Product Change Notification

Change Notification #: 115326 - 00
Change Title: Intel® Server System R2208WT2YSR
PCN 115326-00, Product Design,
Change dimension on PCIe* riser bracket
holes.
Date of Publication: March 06, 2017

Image 1. PCIe* bracket holes

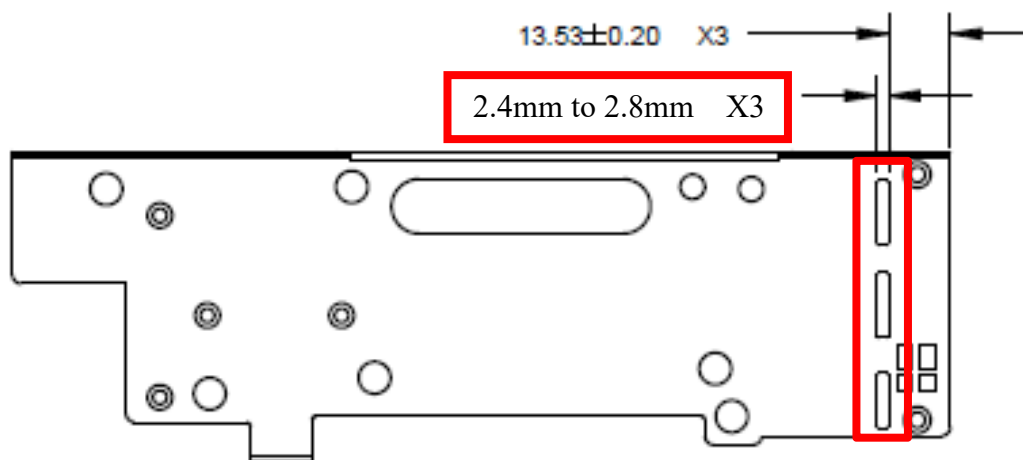
- The width of the holes in the PCIe* Riser bracket change from 2.4mm to 2.8mm. Please see Image below for details.

This change will eliminate any difficulty with customers installing PCIe* cards in riser 2 and riser 3 on opposing PCIe* slots.
